Department of Planning & Infrastructure

Gujarat Underground Expansion: Preferred Project Report

Review of Surface Water Issues

January 2014

GUJARAT NRE COKING COAL LTD.
NRE No.1 COLLIERY
 Additional Overlay Plan A
SURFACE FEATURES
 Showing Cumulative subsidence contours
 for the Bulli and Balgownie Seams

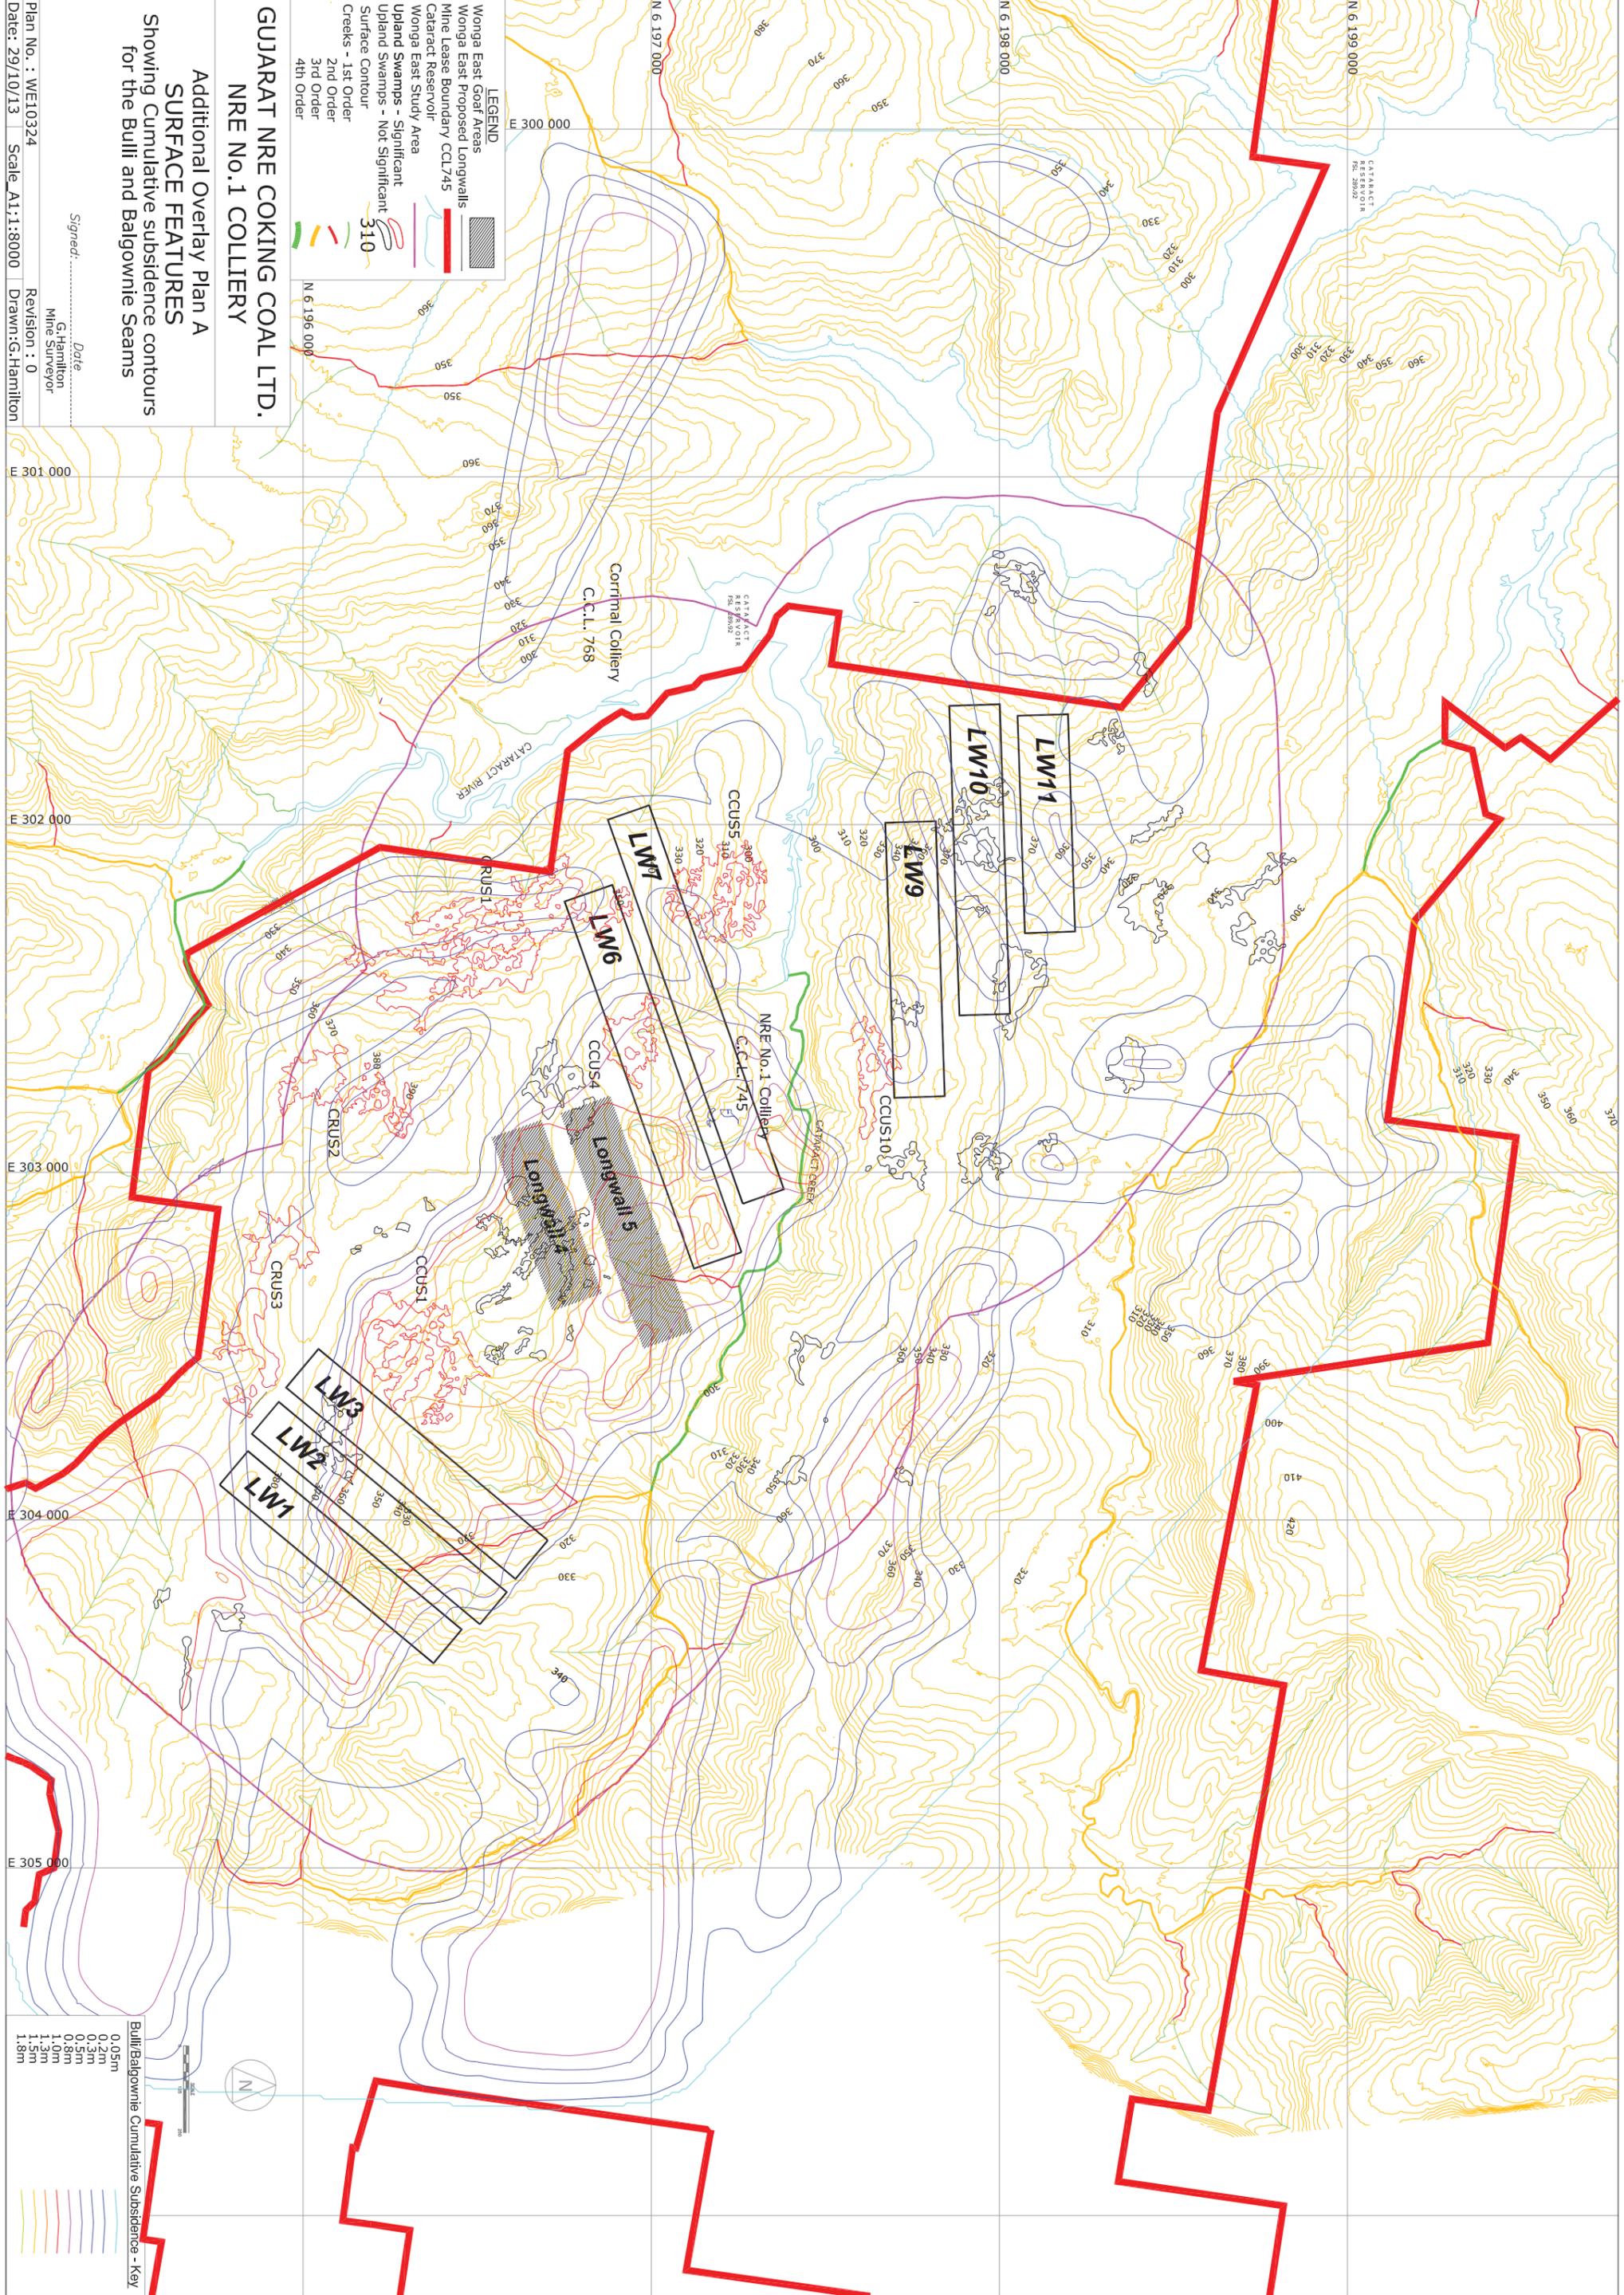
- 2) Water level reduction that can be largely, but not fully, accounted for by evapotranspiration loss. This category includes piezometers PCc4 and PCr1, located in swamps CCUS4 and CRUS1 respectively. **Figure 2.1** shows the cumulative subsidence as a result of mining of the Bulli and Balgownie Seams as 0.9 m and 0.6 m respectively. The slope of the water level drawdown after rainfall cannot be fully explained by evapotranspiration. In particular:

Swamp Name	Characteristics and Subsidence Effects	Potential Impact (This Review)	PPR Assessment (Biosis)
BCUS2	<p>BCUS2, an upland swamp with an area of approximately 0.89 ha, is located north of CCUS9 and CCUS10. BCUS2 slopes northward and has an effective catchment area of approximately 2 ha. No defined drainage outlet is visible on Figure 2.1.</p> <p>Cumulative subsidence effects due to mining of the Bulli and Balgownie Seams are approximately 0.2 m through the middle of the swamp (see Figure 2.1).</p> <p>An additional 0.02 m subsidence is predicted through the middle of the swamp due to mining of the Wongawilli Seam (see Figure 2.2), resulting in negligible convex curvature through or immediately adjacent to the swamp.</p> <p>Any cracking is likely to occur to the south-west of the swamp around the edge of LW9, which could decrease the amount of flow entering the swamp from the catchment. However, as the catchment area is very small, BCUS2 is considered to be at a low risk of negative environmental consequences.</p>	Low risk	-

BCUS4	<p>BCUS4, an upland swamp with an area of approximately 2.2 ha, is located directly downhill of BCUS11, which decreases the effective catchment area for the swamp. BCUS4 slopes north-east, and has an effective catchment area of approximately 7 ha.</p> <p>Biosis flow accumulation modelling pre-mining indicates that there is a dispersed flow through the swamp, with four exit points from the base of the swamp. These flow pathways are not visible on Figure 2.1.</p> <p>Cumulative subsidence effects due to mining of the Bulli and Balgownie Seams range between 0.2 m at the north east edge and 0.5 m at the south west edge of the swamp (see Figure 2.1).</p> <p>LW10 is to be located directly below the south edge of BCUS4. Additional subsidence ranging from 0.1 m at the north-east edge to 1 m at the southern edge is predicted due to mining of the Wongawilli Seam (see Figure 2.2).</p> <p>Convex curvature through the centre of the swamp may result in cracking at the north-east edge (downhill side) of the swamp. This is likely to alter the flow paths exiting the swamp. As such, BCUS4 is considered to be at minor risk of negative environmental consequences.</p>	Minor risk	Moderate risk

BCUS7	<p>BCUS7, an upland swamp with an area of approximately 0.62 ha, is located to the west of BCUS6. BCUS7 slopes north-east, and has an effective catchment area of approximately 2 ha. No defined drainage outlet is visible on Figure 2.1.</p> <p>Cumulative subsidence due to mining of the Bulli and Balgownie Seams is approximately 0.2 m beyond the south-west and south-east edges of the swamp.</p> <p>An additional 0.02 m subsidence is predicted through the middle of the swamp due to mining of the Wongawilli Seam, resulting in negligible convex curvature through or immediately adjacent to the swamp.</p> <p>Any cracking is likely to occur to the south of the swamp around LW11, which could decrease the amount of flow entering the swamp from the catchment. However, as the catchment area is very small, BCUS7 is considered to be at a low risk of negative environmental consequences.</p>	Low risk	-

Figure 3.1:
Daily Rainfall and Swamp Piezometer Hydrographs for the Wonga East Area

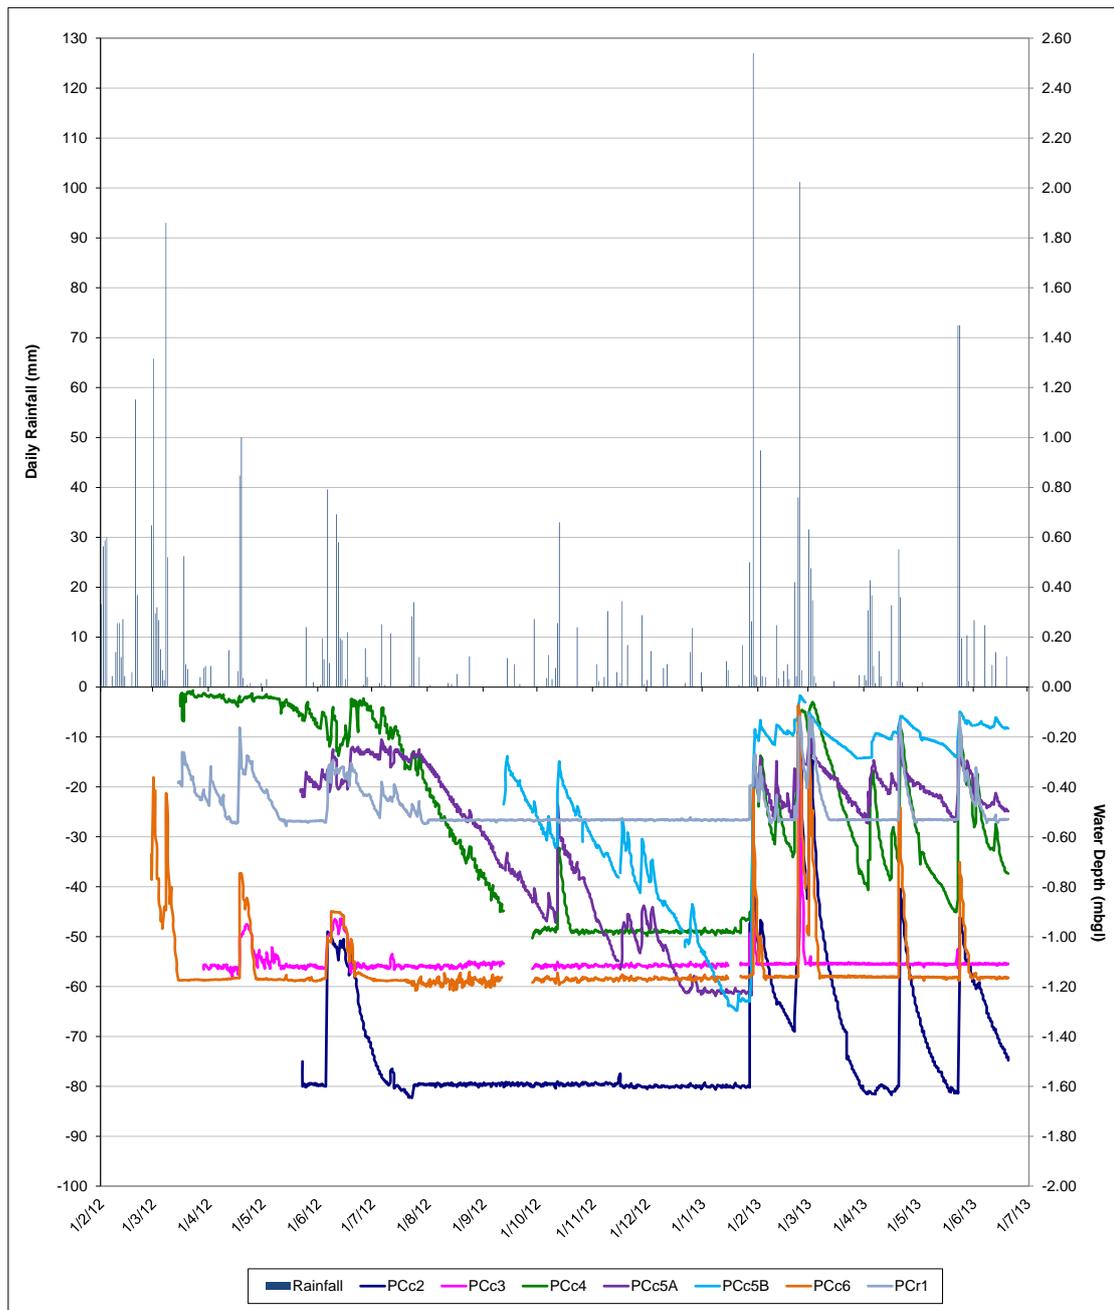
- 1) Water level reduction that can be accounted for by evapotranspiration loss. This category includes piezometers PCc5A and PCc5B, both of which are located in swamp CCUS5 in which the water level was drawn down below the interface between the swamp and the underlying weathered sandstone in January 2013. This swamp was subject to an estimated 0.6 m maximum subsidence along its south-eastern edge as a result of mining of the Bulli and Balgownie Seams (see **Figure 2.1**). While the estimated subsidence occurred to the south-east of the locations of the piezometers, the hydrographs infer that water retention characteristics of CCUS5 have not been affected by subsidence.

- Similar rapid falls in the water level following the rainfall events in February to May 2013;
 - In the case of PCr1, the water level shows relatively muted response to rainfall in the period up to the end of July 2012. The hydrograph shows no response to the rainfall events in mid-September and mid-October 2012, suggesting that the water level recorder malfunctioned.

It is interesting to note that the recorded water level in PCc4 fell to a level of about 0.95 m below ground level in the period between November 2012 and late January 2013. As this level is below the quoted depth of the base of the piezometer, the accuracy of the level measurements is questionable.

- 4) Rapid water level lowering following rainfall, typically falling back to a 'base' level within 5 to 10 days of rainfall, which suggests that water is being lost from the base of the swamp into the underlying sandstone. Piezometers PCc3 and PCc6 (swamps CCUS3 and CCUS6) are examples of this behaviour. Both these swamps are located over LW4 and LW5 and were subject to 1.0 m and 1.8 m maximum subsidence respectively, as a result of previous mining (see **Figure 2.1**). LW4, which runs beneath CCUS6, was extracted between 19 April and 18 September 2012. Because the site of the piezometer is about 30% of the way along the longwall, the site of piezometer itself is unlikely to have been undermined before the start of June 2012. The start of mining occurred after the rise and rapid fall of water level following rainfall in February and early March 2012 (which led to persistent elevated water levels at

Figure 5.1:
Cataract Creek Bed Profile

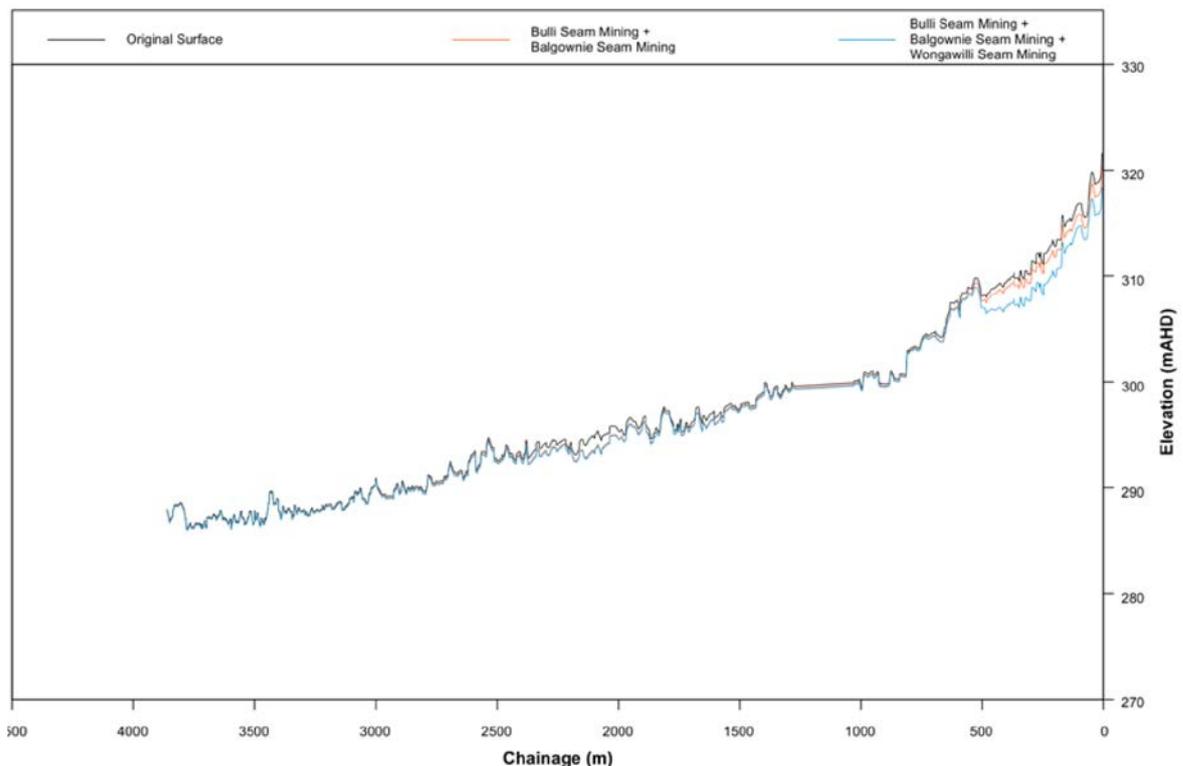
The profile in **Figure 5.1** shows the following features of note:

The *Subsidence Assessment* also notes other subsidence effects on creeks that are not shown on **Figure 5.1:**
